SUBJECT: ISSUANCE OF AMENDMENT NO. 115 TO FACILITY OPERATING LICENSE NO.
DPR-23 - H. B. ROBINSON STEAM ELECTRIC PLANT, UNIT NO. 2,
REGARDING OPERATION OF PLANT BELOW 1380 Mwt (TAC NO. 67198)

ATTACHMENT TO LICENSE AMENDMENT NO. 115

SAFETY EVALUATION BY THE OFFICE OF NUCLEAR REACTOR REGULATION
RELATED TO AMENDMENT NO. 115 TO FACILITY OPERATING LICENSE NO. DPR-23
CAROLINA POWER & LIGHT COMPANY
H. B. ROBINSON STEAM ELECTRIC PLANT, UNIT NO. 2
DOCKET NO. 50-261

FIGURE 3.10-3 NORMALIZED AXIAL DEPENDENCE FACTOR FOR F_q VERSUS ELEVATION (PEAK $F_q = 2.32$)

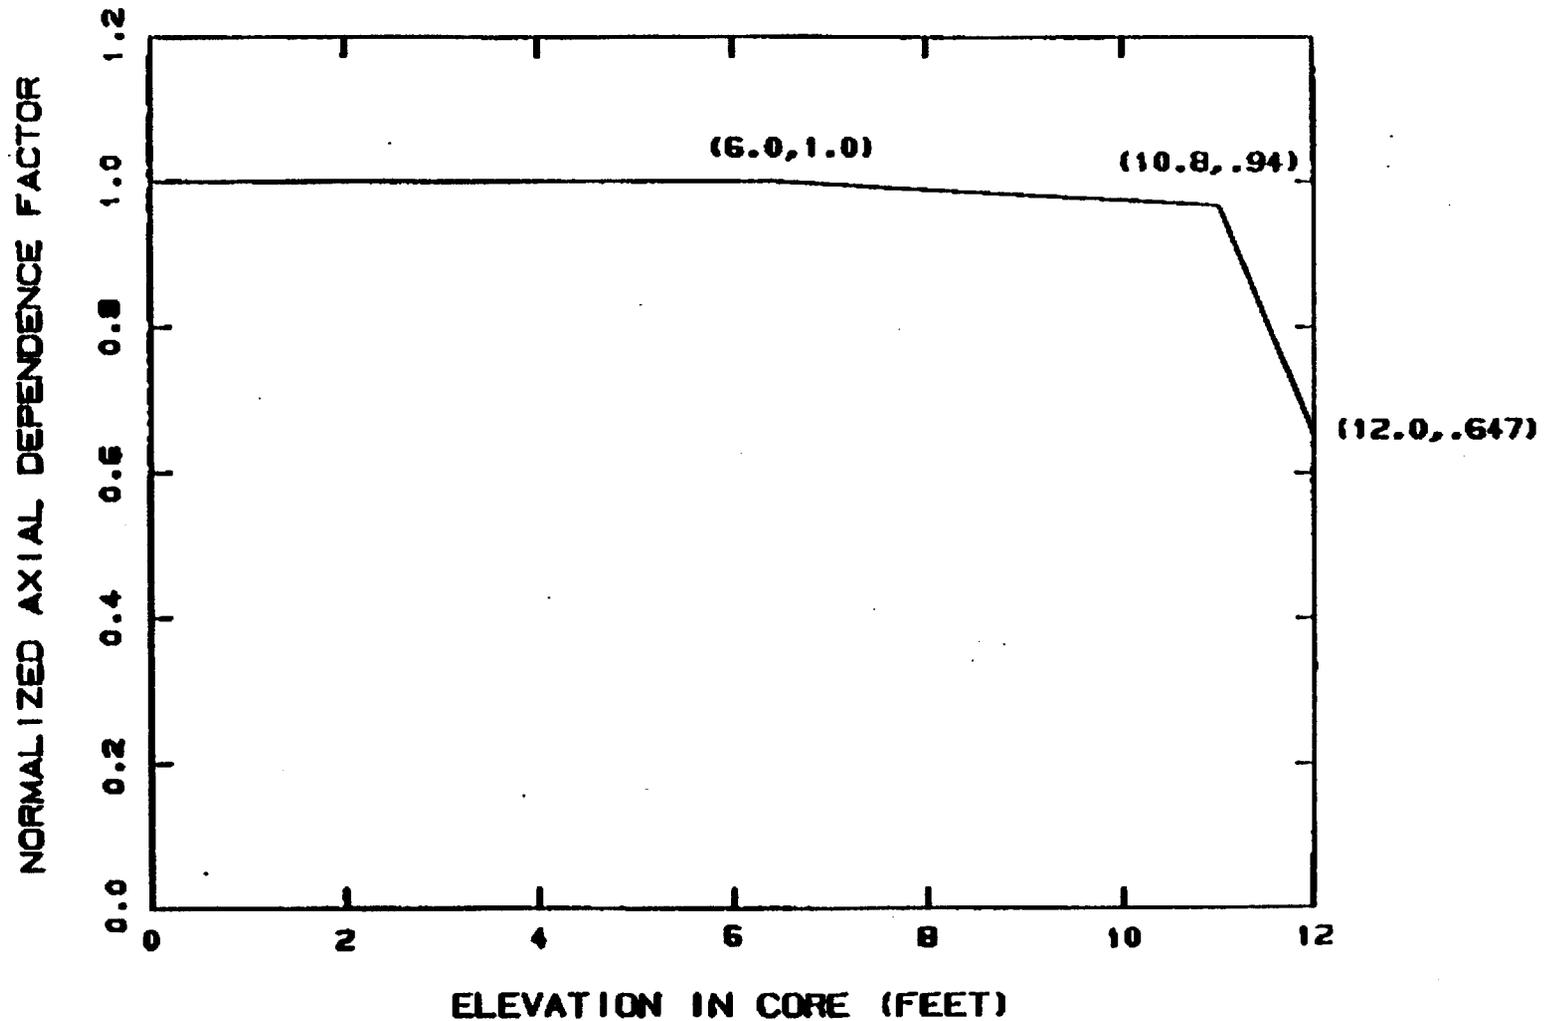
Note: With only two safety injection pumps operable, each capable of automatic initiation from a separate emergency bus, peak $F_q = 2.26$.

(3) Technical Specifications 3.10.2.1, 3.10.2.2, 3.10.2.2.1, 3.10.2.2.2 and Figure 3.10-3.

Notes are added to the related sections regarding reduction of the power peaking factor (F_0) from 2.32 to 2.26 for conditions with only two SI pumps operable above 50% of full power. The corresponding value for power levels less than 50% of full power decreases from 4.64 to 4.52. The corresponding Axial Power Distribution Monitoring System value is reduced proportionally from 2.103 to 2.049. These changes are consistent with the assumptions used in the supporting analysis and are acceptable.
